ADDENDUM NO. 3

Warren Central High School Phase 3 Renovation and Addition 9500 E. 16th Street Indianapolis, IN 46229

This Addendum forms a part of and modifies the Bidding Requirements, Contract Forms, Contract Conditions, the Specifications and the Drawings dated January 3, 2023, by CSO Architects. Acknowledge receipt of the Addendum in the space provided on the Bid Form. Failure to do so may subject the Bidder to disqualification.

DRAWING NUMBER A900B

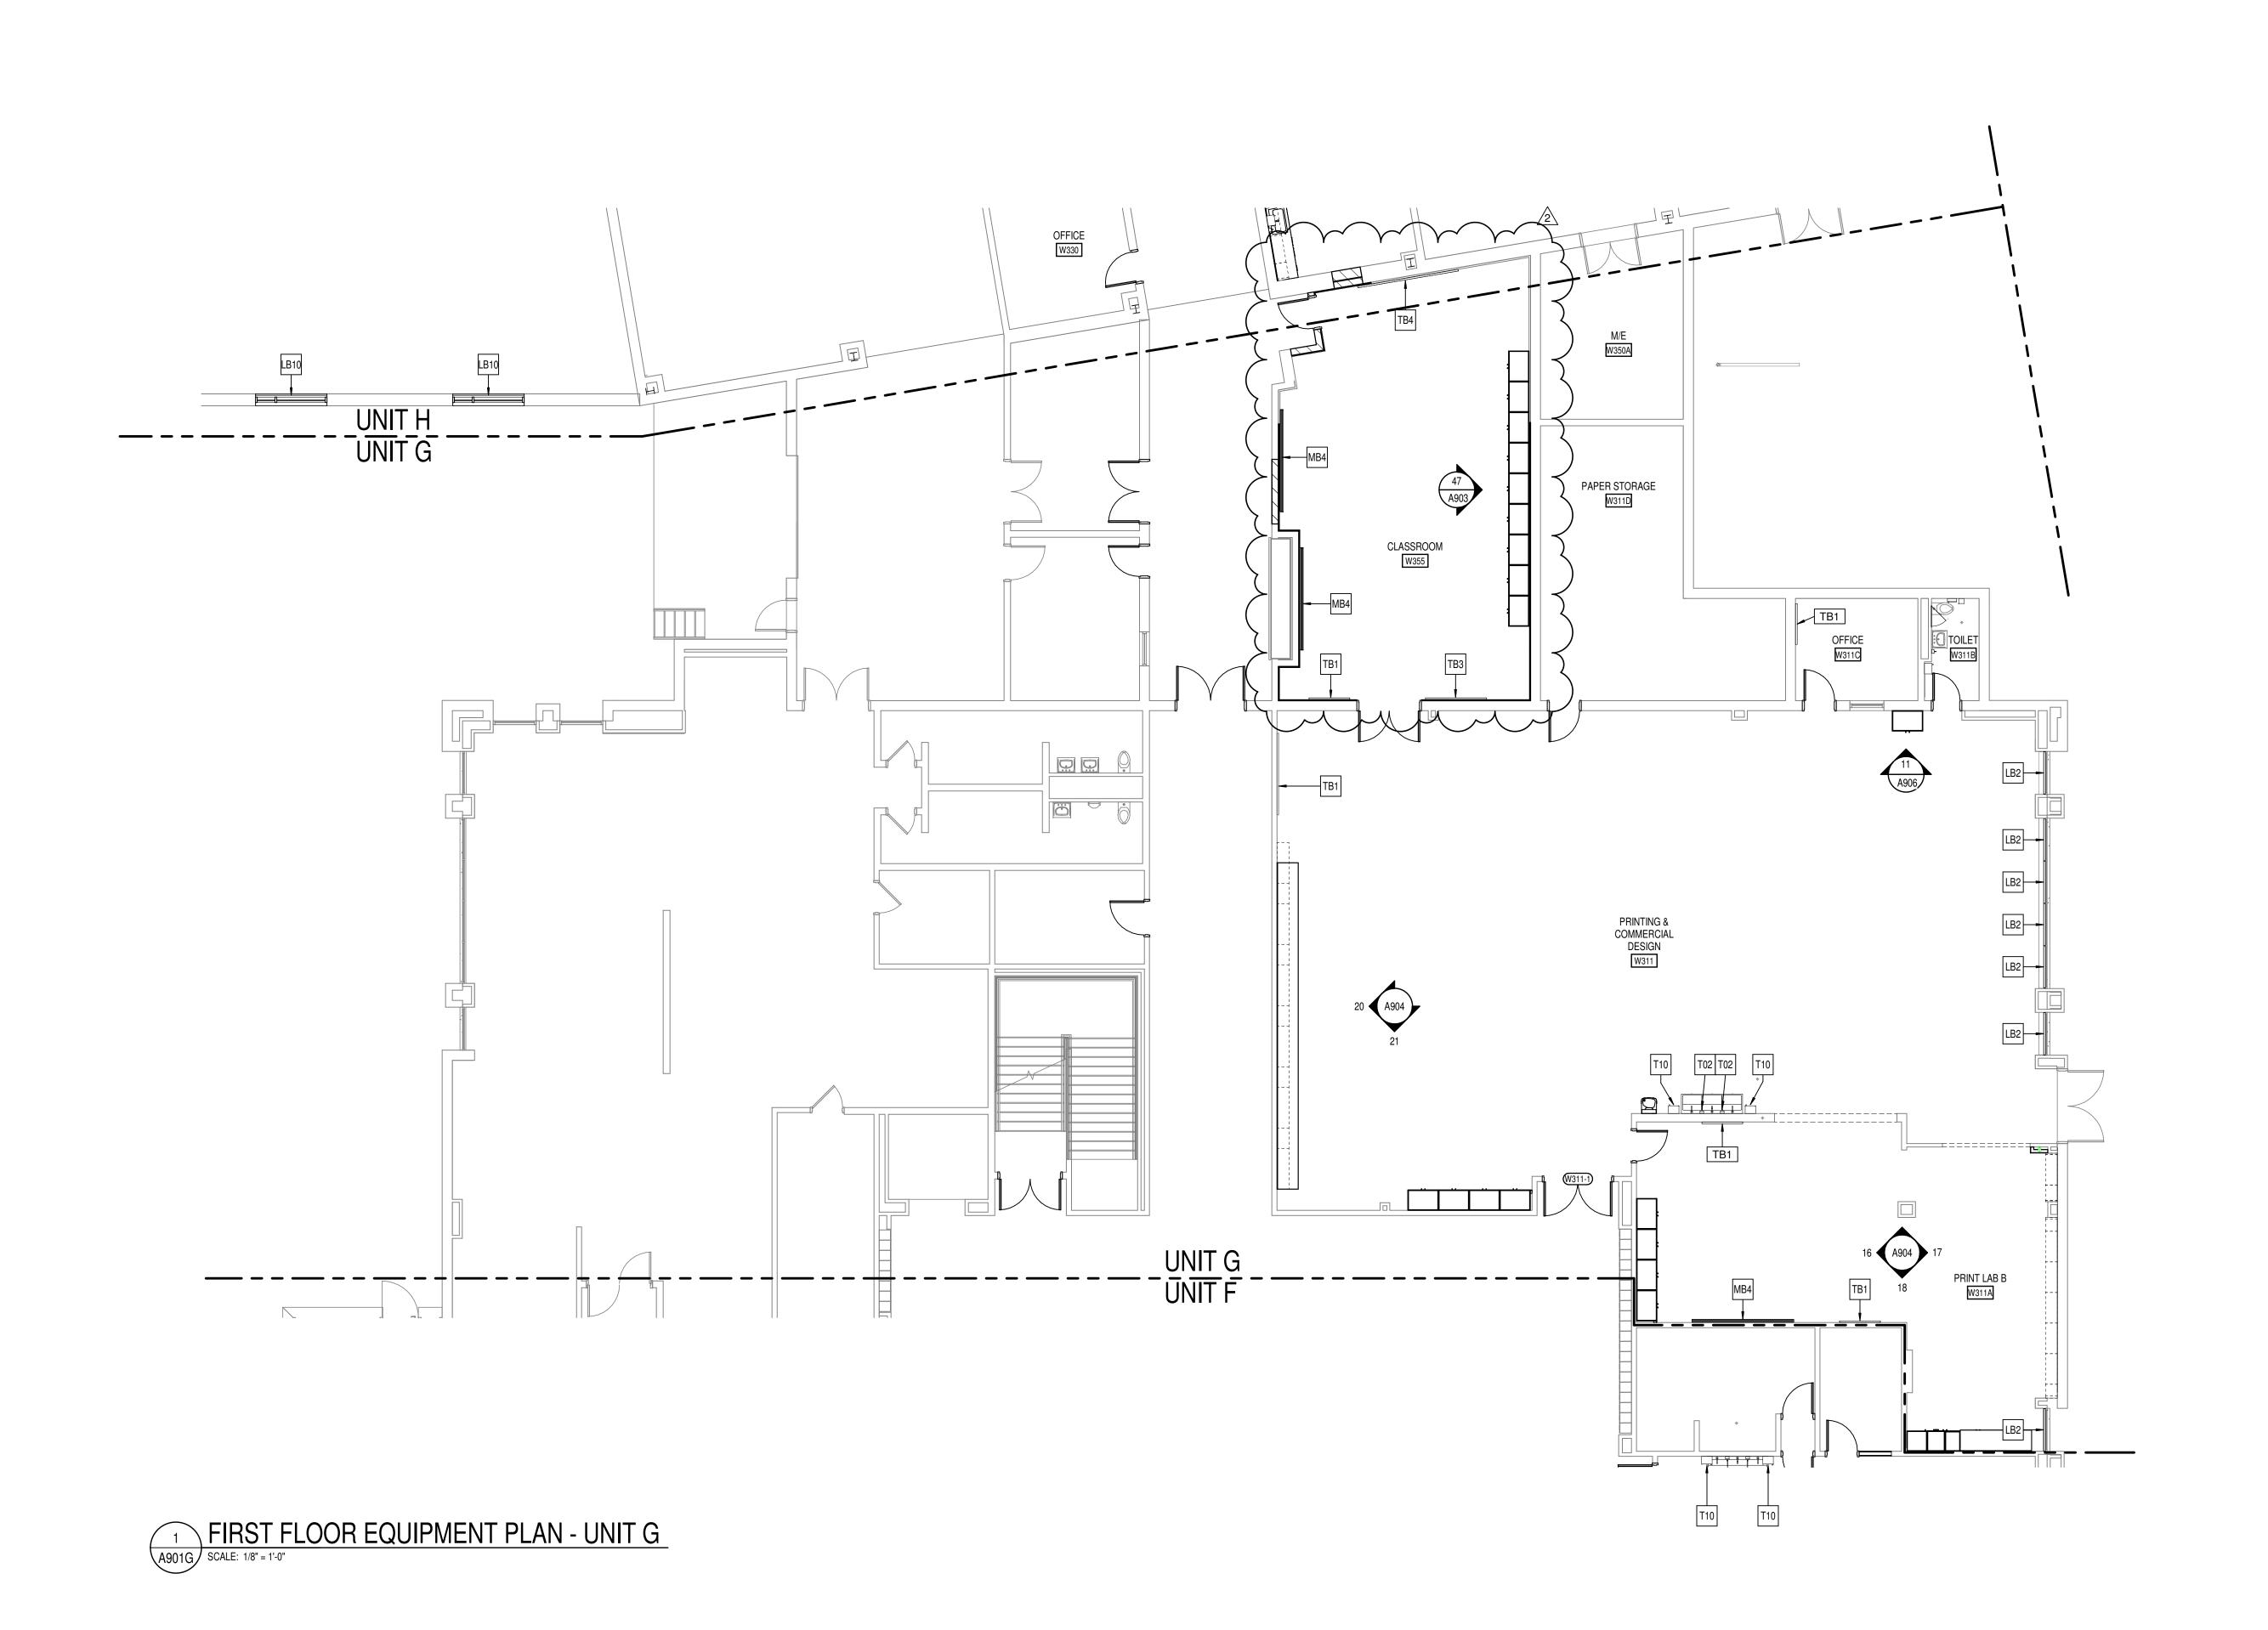
- A. REVISE L1, L2, and L3 information as indicated on attached, re-issued Sheet A900B.
- B. ADD equipment to the schedule related to barbering and salon equipment as indicated on attached Sheet.

DRAWING NUMBER
A901M

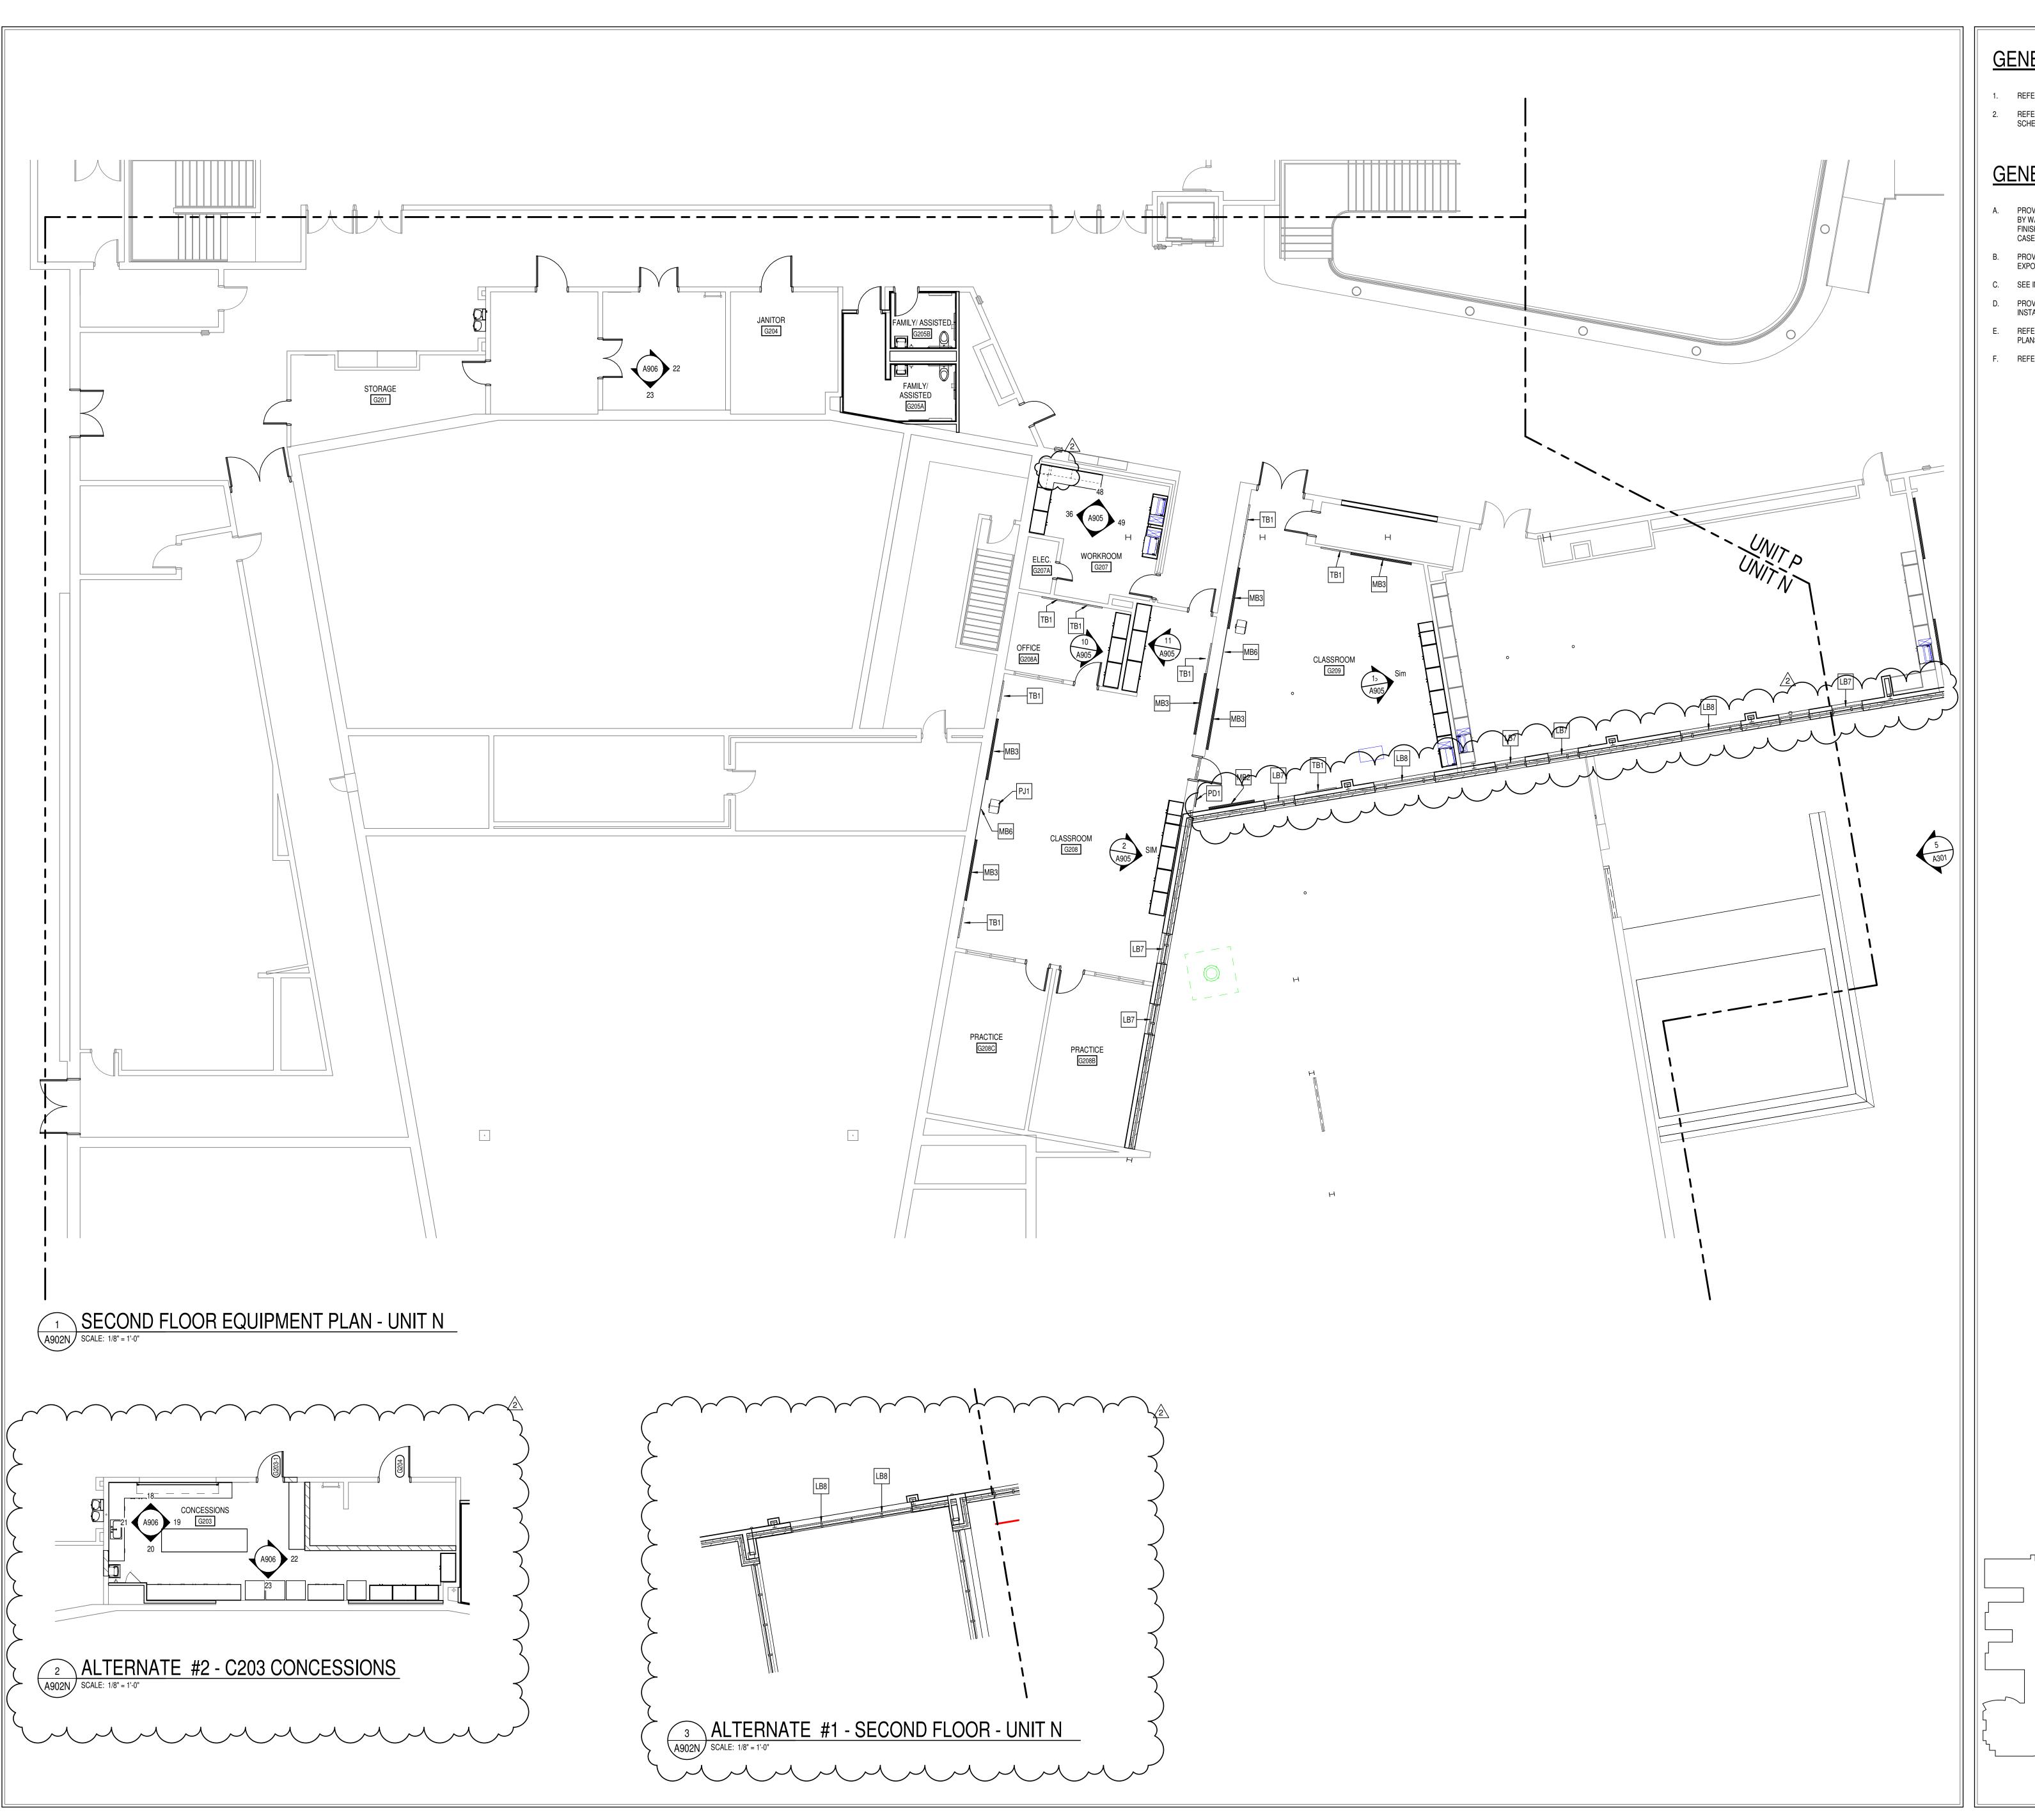
A. ADD reference tags to barbering and salon equipment as indicated on attached, re-issued Sheet A901M.

DRAWING NUMBER A902N

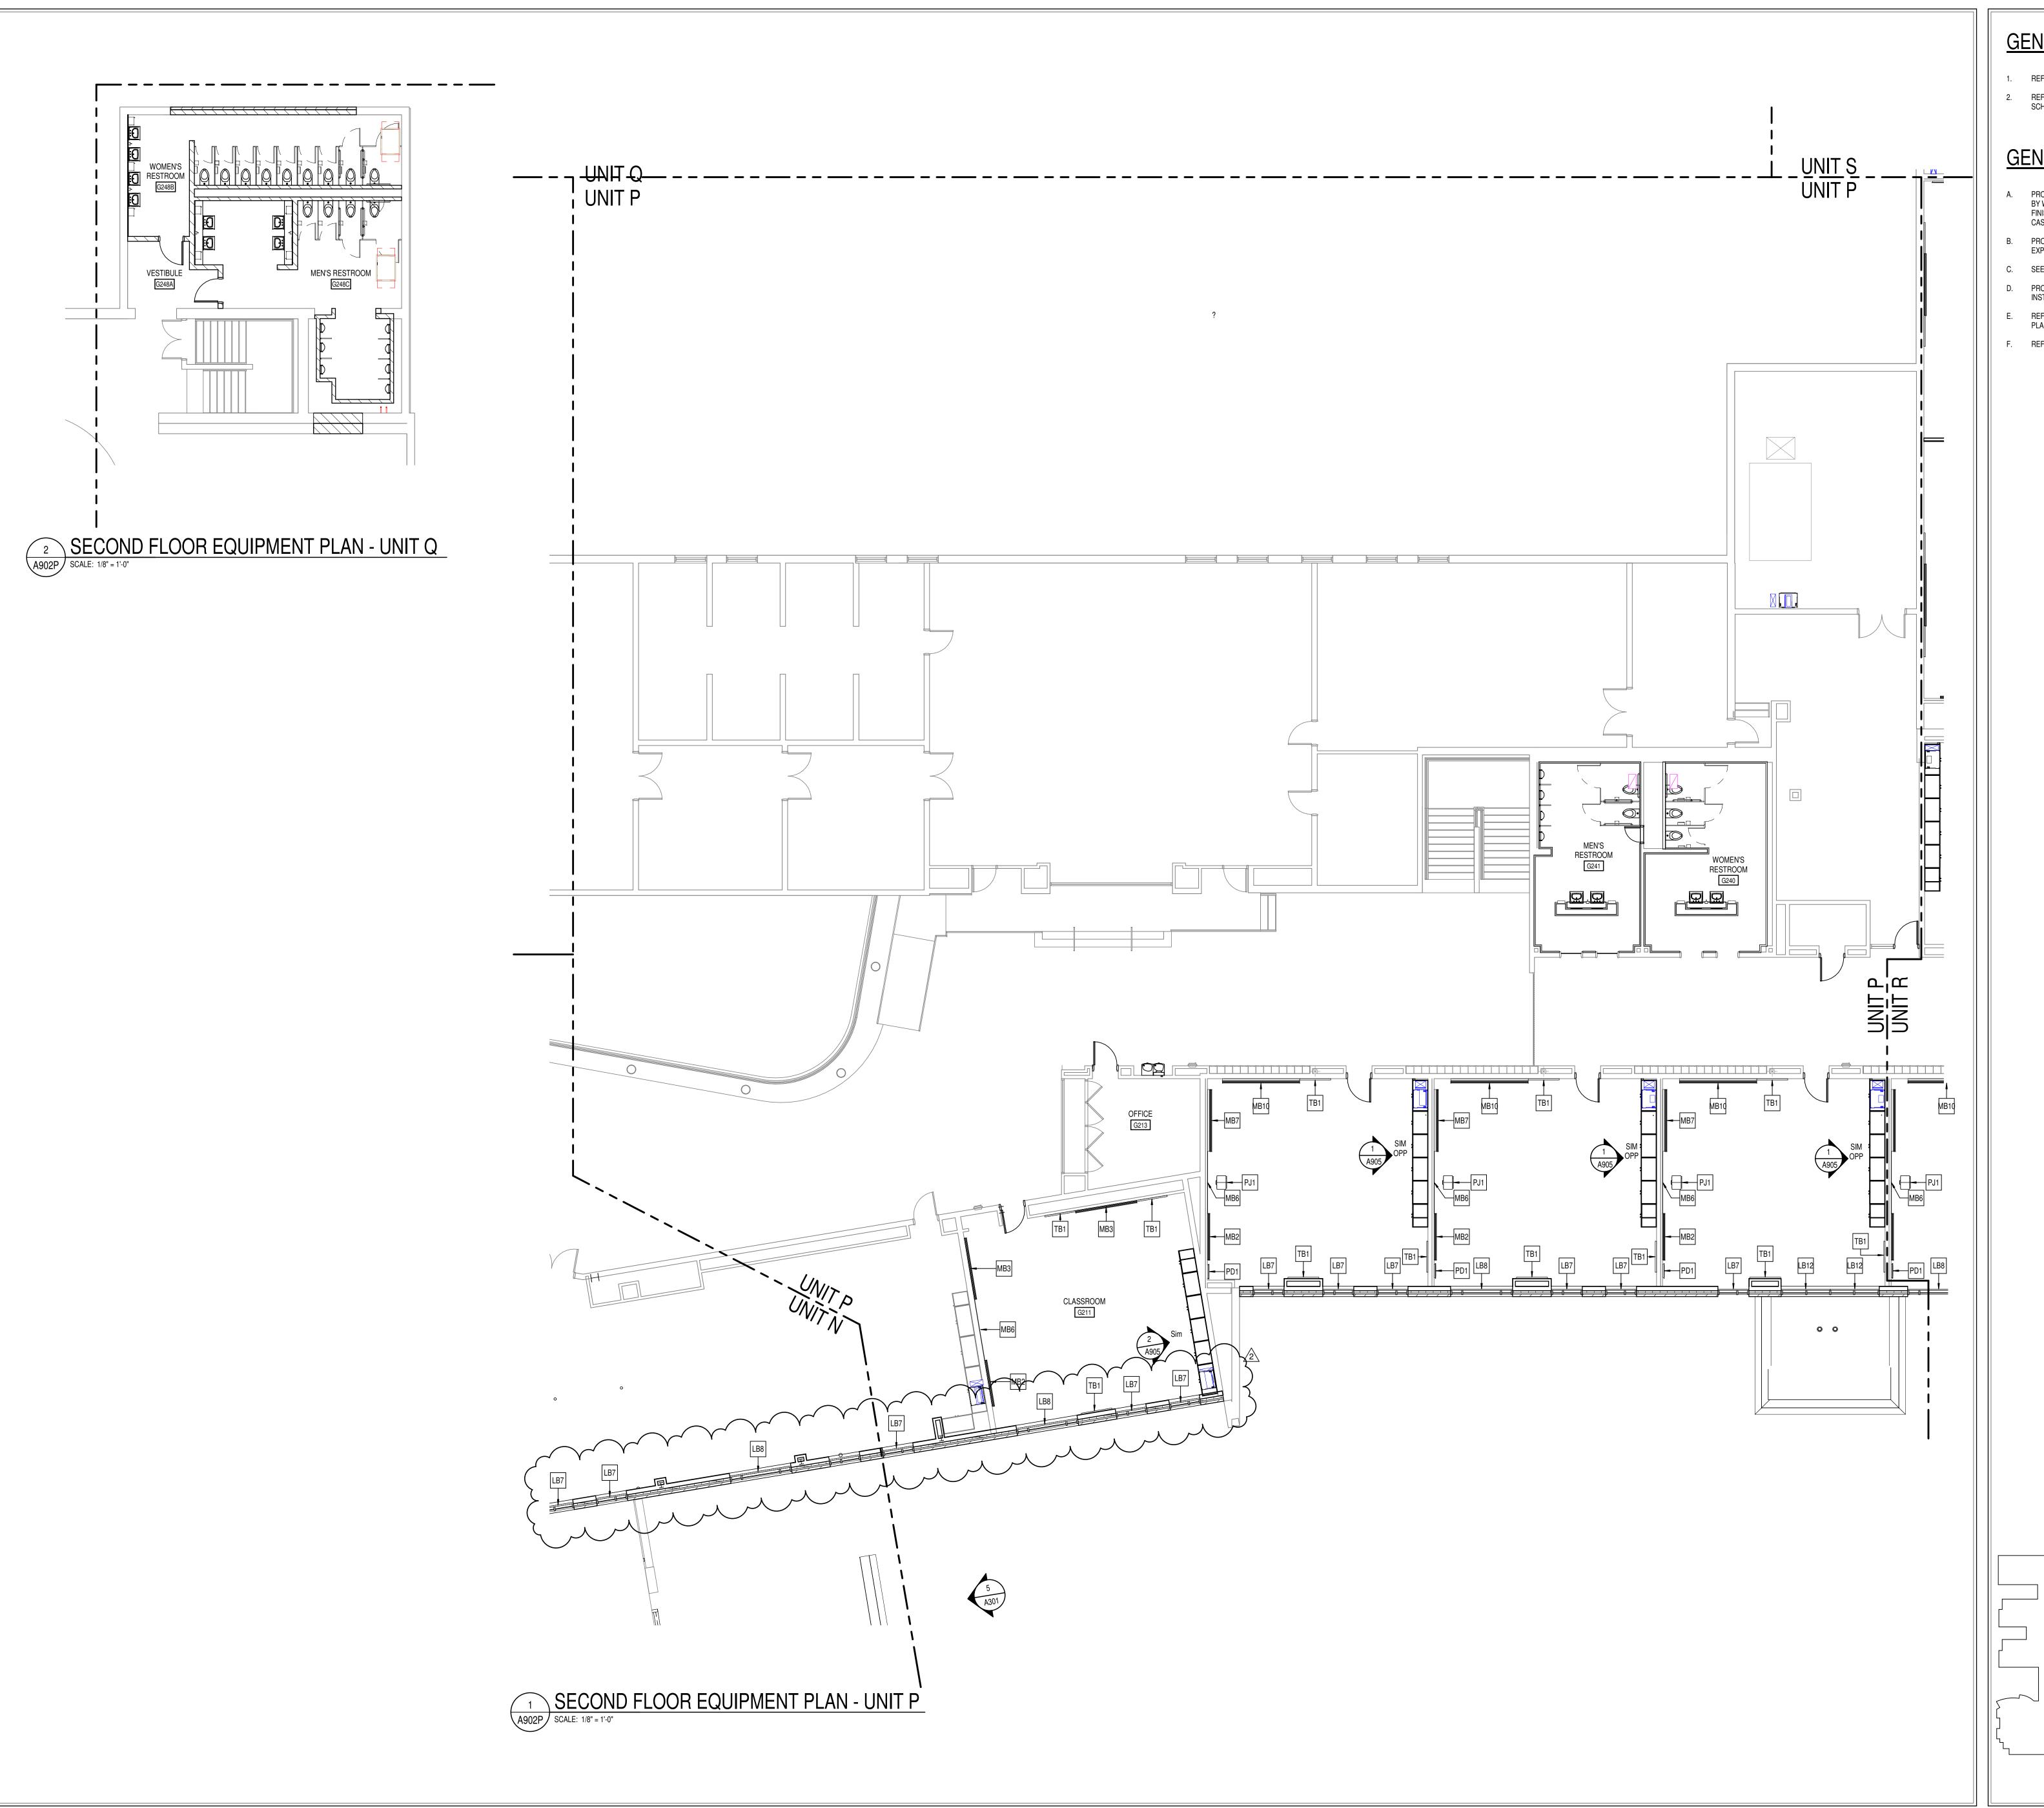
A. ADD Plan 2/A902N as indicated on attached, reissued Sheet A902N.
